Addendum #2
Bid Opportunity: 24-7540-RFT - Pioneer Park
Public School Interior Renovations
Revised Closing Date: Tuesday, April 16, 2024 2:00 PM

Project Name:	WRDSB Pioneer Park PS Renovations	Date Issued:	April 10, 2024
Quasar Project #:	CM-19-083		
Distribution			
Ward99	Tina Ranieri-D'Ovidio		tr@ward99architects.com
Quasar	Michael Hughes		Michael.hughes@quasarcg.com
Addendum #:	M2		
Revision #:	0

Project Name:	WRDSB Pioneer Park PS Renovations	Date Issued:	April 9, 2024
Quasar Project #:	ED-20-312

M201

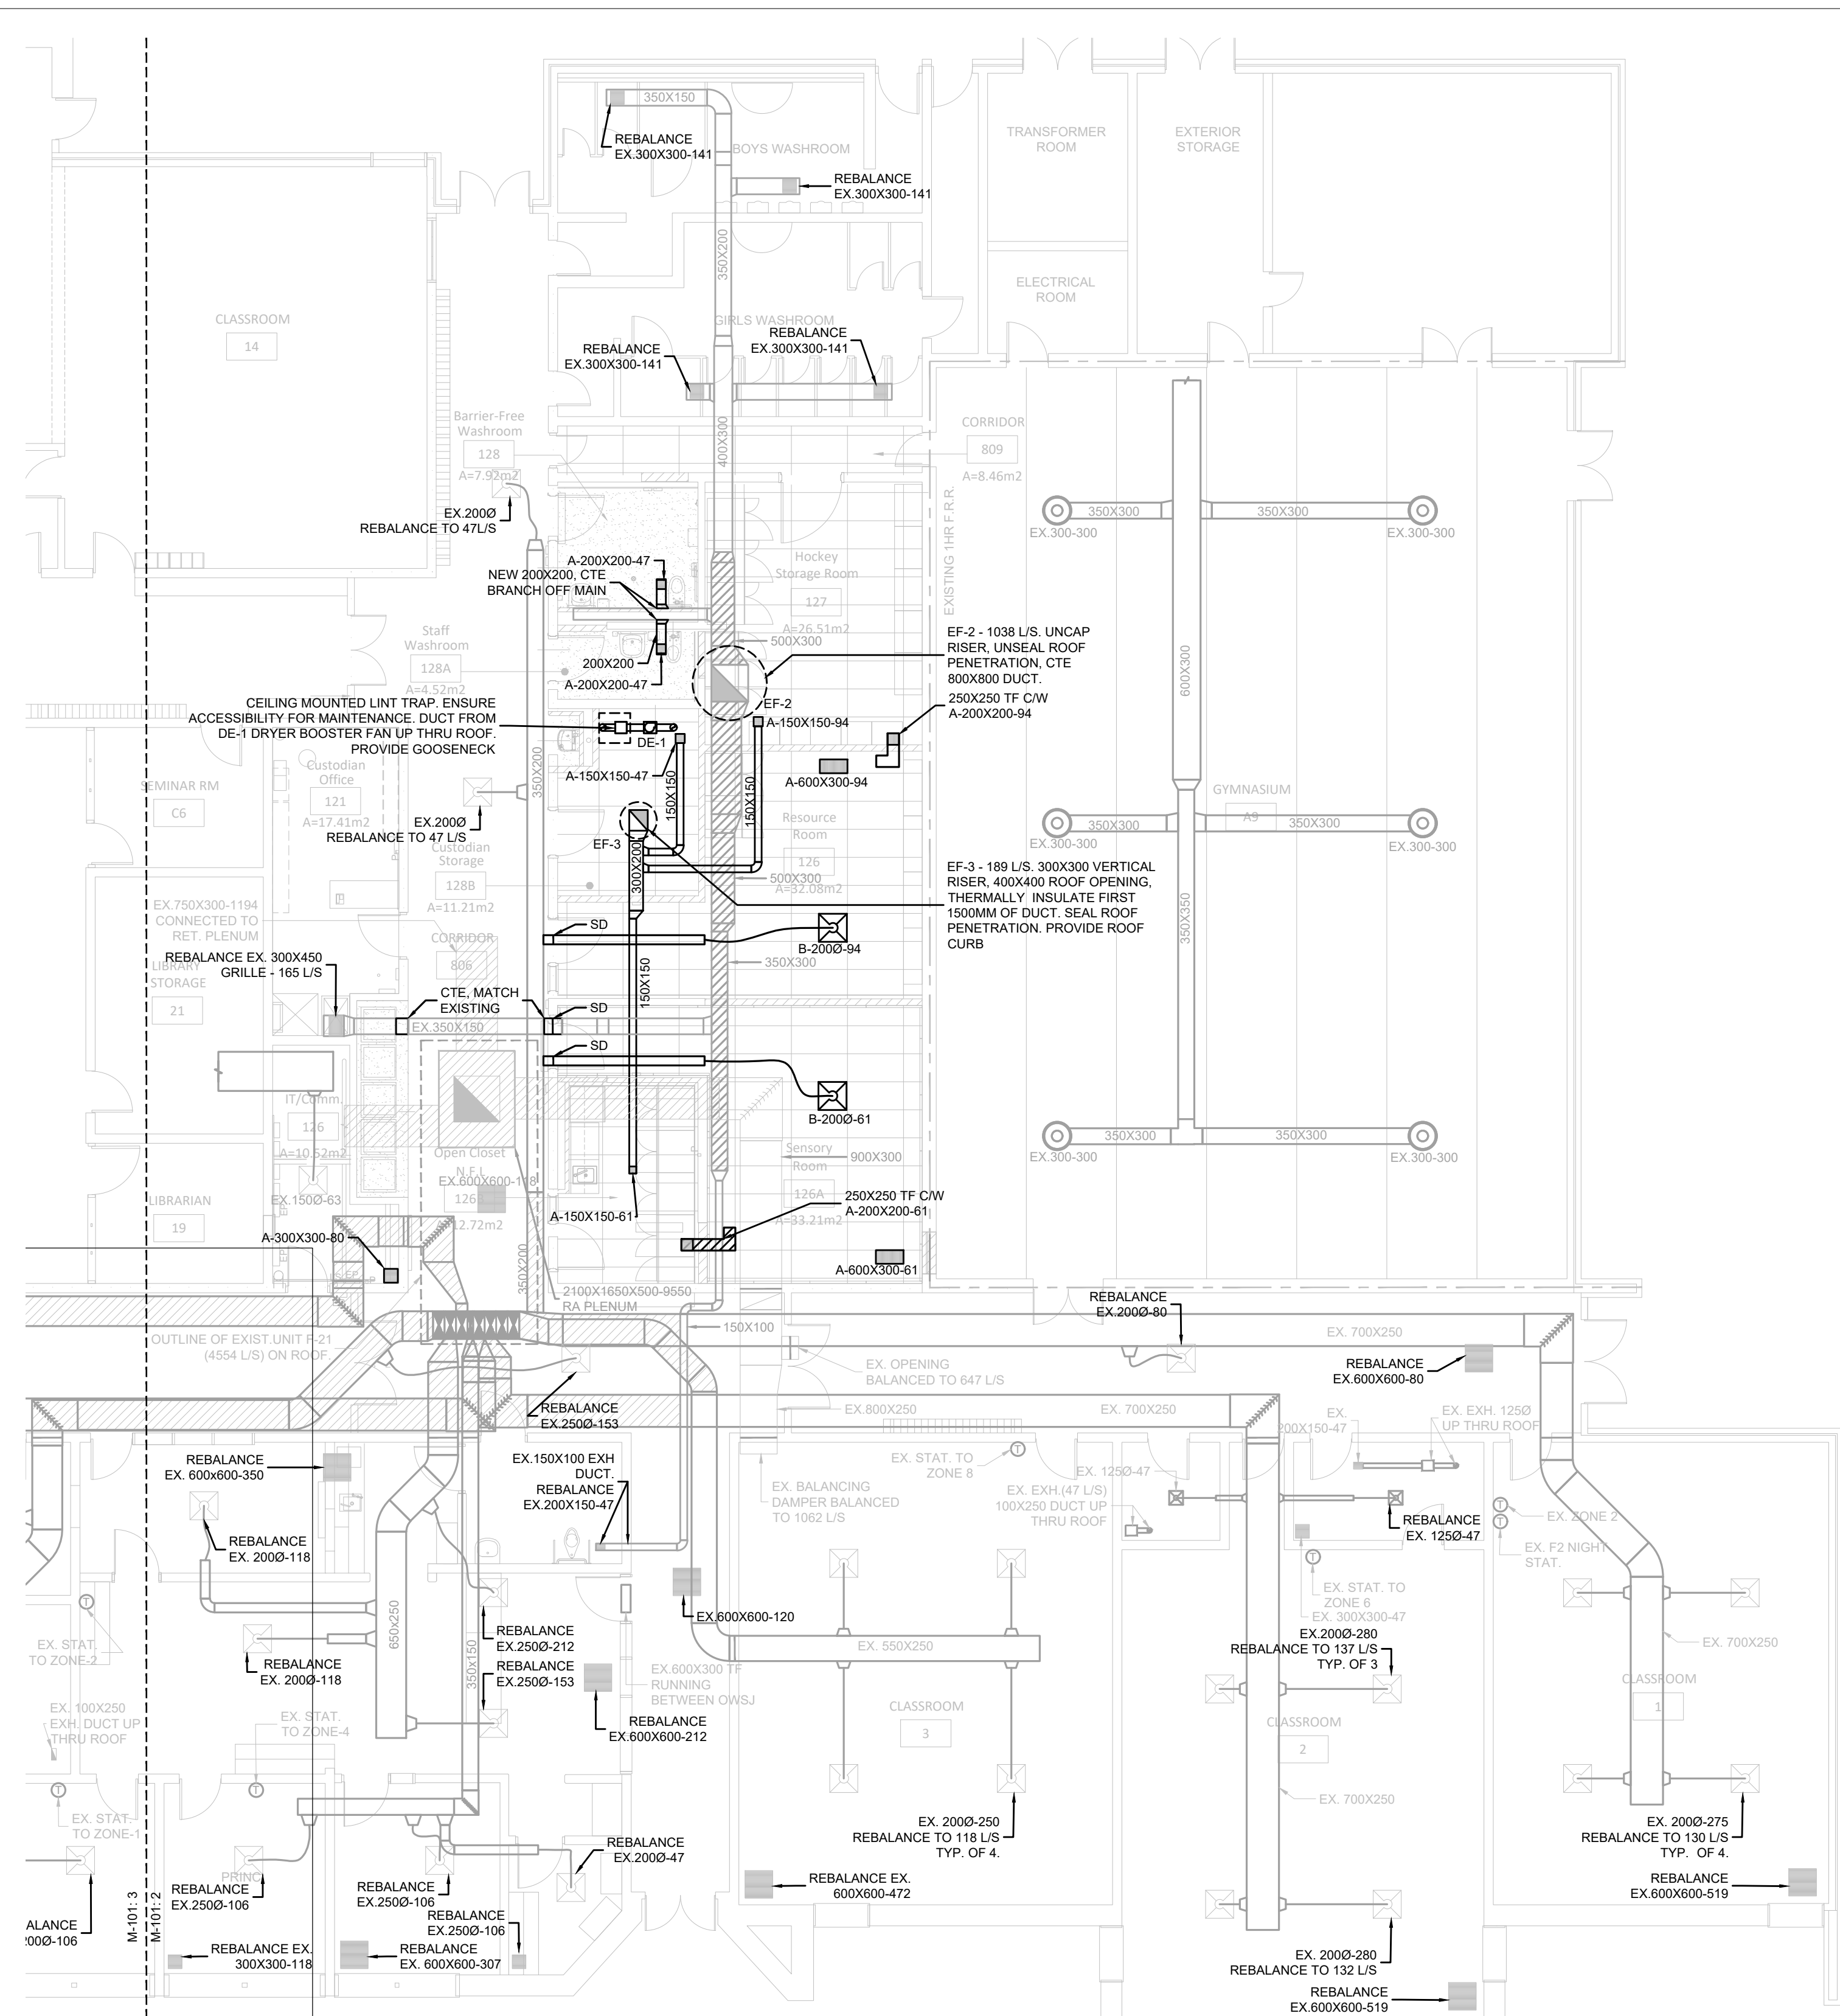
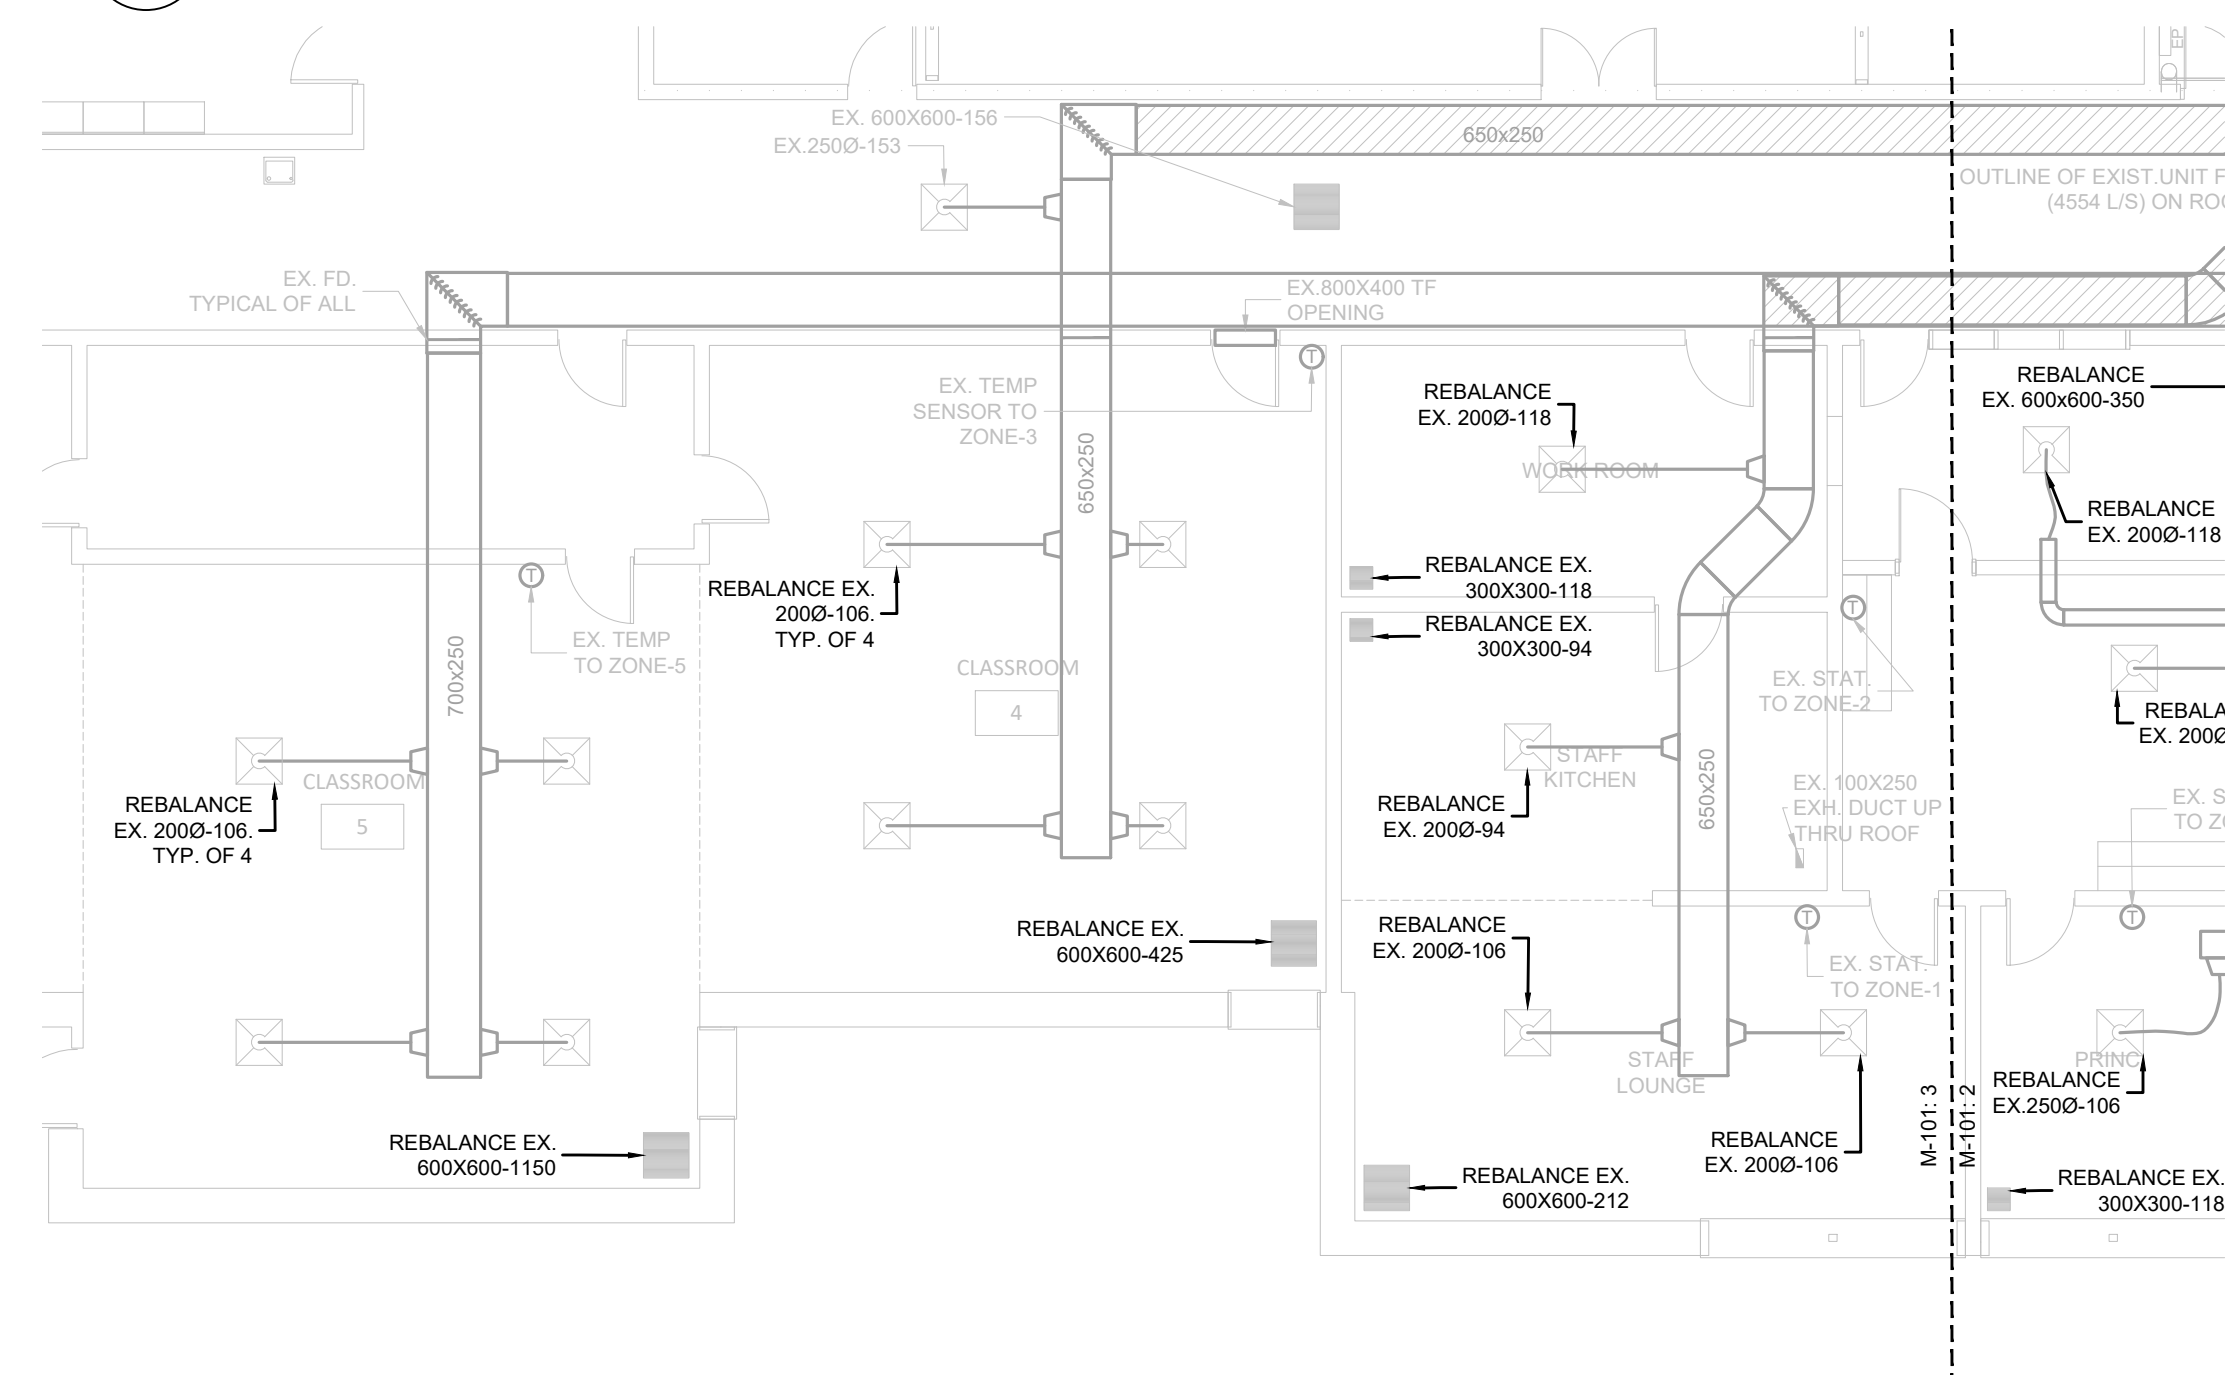
1. **M101 – PARTIAL GROUND FLOOR DEMOLITION PLAN**
 Refer to attached drawing and include for all work shown including the below revisions:
 - a. Added note for existing bottle filling station to be removed and reinstalled.
2. **M201 – PARTIAL GROUND FLOOR NEW WORK**
 Refer to attached drawing and include for all work shown including the below revisions:
 - a. Added note for existing bottle filling station to be reinstalled.
